WELL API NO. 30-039-27796
5. Indicate Type of Lease STATE <input type="checkbox"/> FEE <input type="checkbox"/>
6. State Oil & Gas Lease No.
7. Lease Name or Unit Agreement Name RINCON UNIT
8. Well Number #408
9. OGRID Number 189071
10. Pool name or Wildcat BASIN DAKOTA/BLANCO MESAVERDE

SUNDRY NOTICES AND REPORTS ON WELLS

OTHER: CHANGE OF PLANNED FACILITIES ☒

SITE PLAN

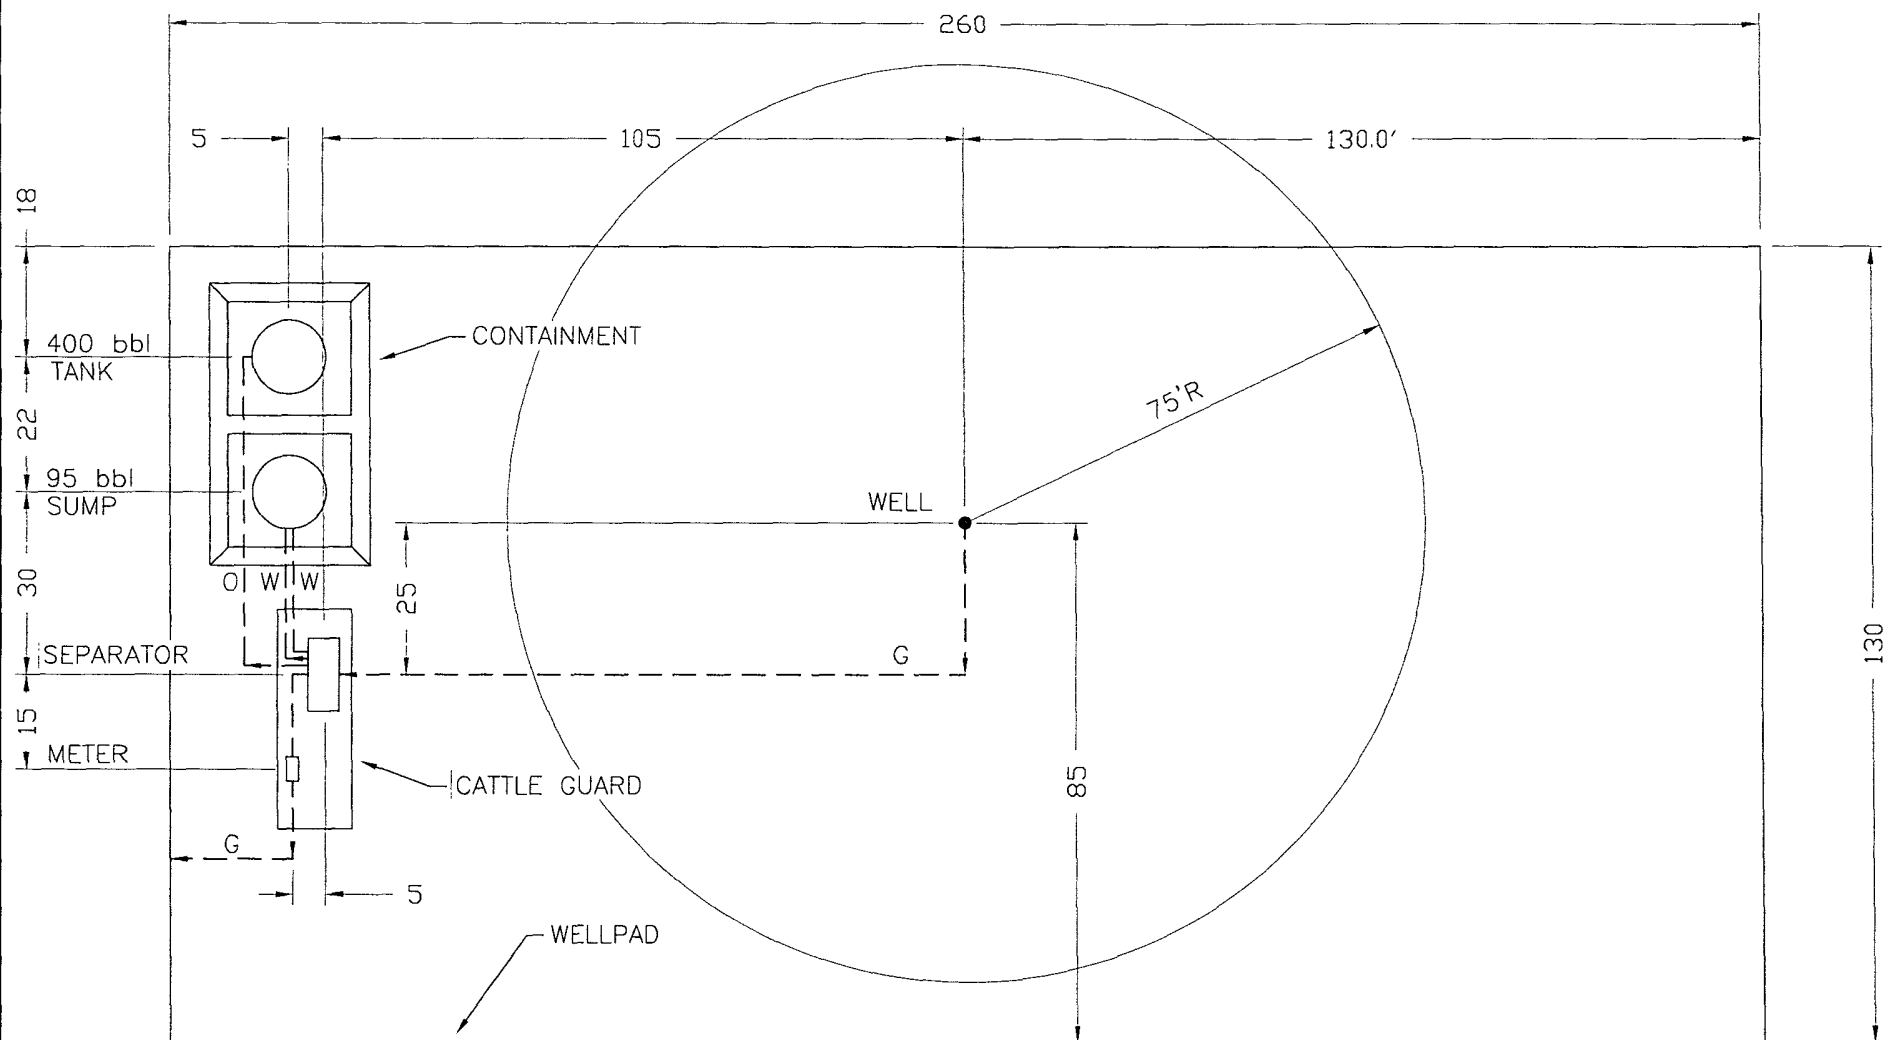
Chevron MidContinent, L.P. reports that we have changed our planned facilities for the above mentioned location. A ~400 BBL steel tank, a ~95 BBL below-grade steel tank, a separator, and an Enterprise meter run will be installed on the well pad. Attached is a basic diagram of how these facilities would be arranged on a wellsite and a basic diagram of the 95Bbl below-grade steel tank. Should you have any questions or require any additional information, please feel free to contact us at anytime.
